## MCMBRA/RB-Ø32/Ø40-(A) Cover Seals Removal Notification

MCMBRA/RB-Ø32/Ø40-(A)

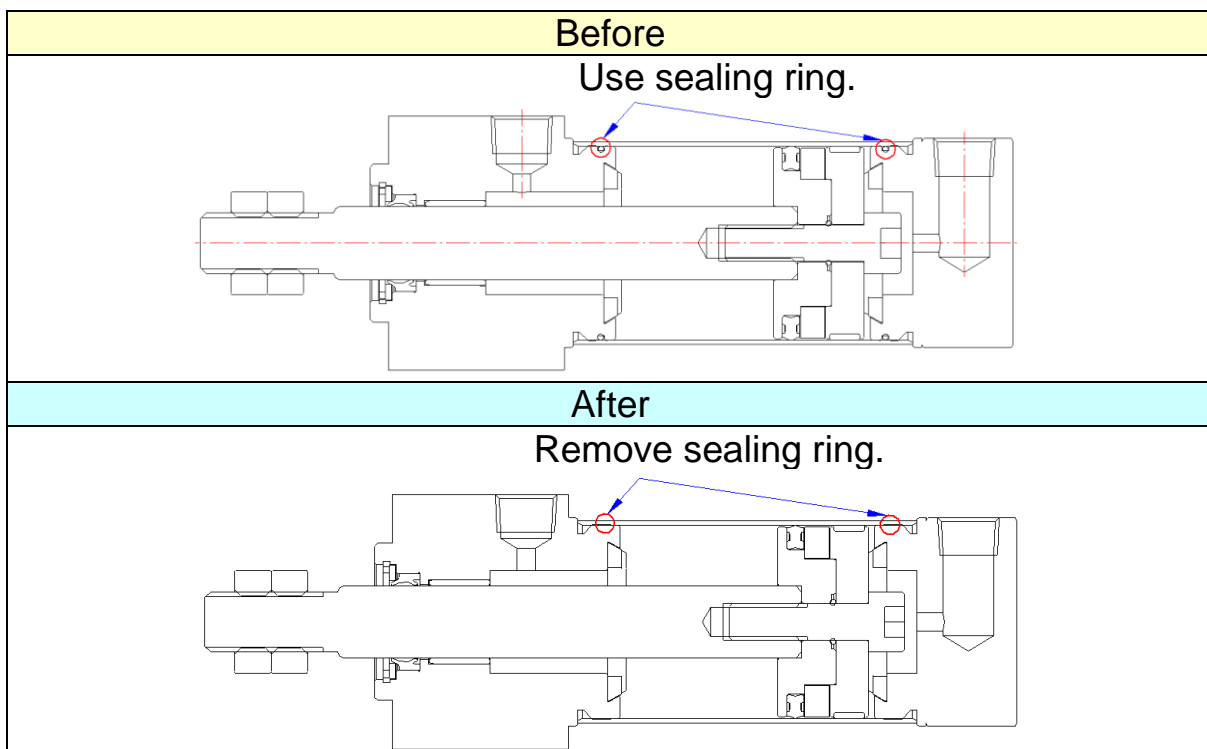
Optimize the assembly sequence.

The cover sealing rings have been removed for the following models:  
Size Ø32 with stroke less than 400 mm. Size Ø40 with stroke less than 300 mm.
